# Access Compliance Report

## Public Rights-of-Way

Intersection ID: 11972	Main Street: N_POPLAR_ST	Cross Street: W_5TH_ST	Location: S
ADA ID: 5E3FF27B9500	Ramp Type: PerpDiag	Initial Pass/Fail: Pass	Overall Compliance: No
			Severity Score: 10.25

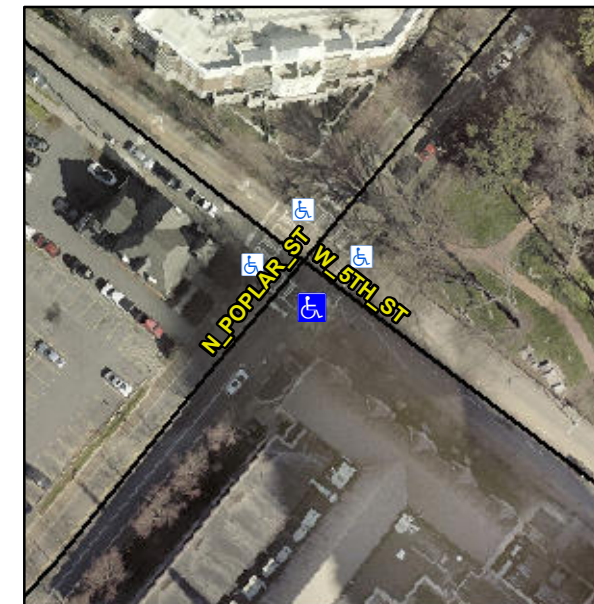
**Not Found, R304.2.2-Perp, R304.3.2-Para, R305**

Yes	Ramp inside XWalk1?	Yes	Yes	Ramp inside XWalk2?	Yes
	Road Slope (%)	3.1	N/A	Clear Space?	Yes
	Road X Slope (%)	0.8	No	Clear Space to XWalk (in)	26.0
Yes	Any Obstructions?	No	Yes	Storm Grate/Utility Hazard?	No
	Obstruction Type			Storm Grate/Utility Type	
			N/A		N/A
			Yes	Surface Condition? (G/P)	Good

**Remove & Replace Curb Ramp With Two New Directional Ramps or Equivalent. Restripe Crosswalk(s) To Provide Clear space.**
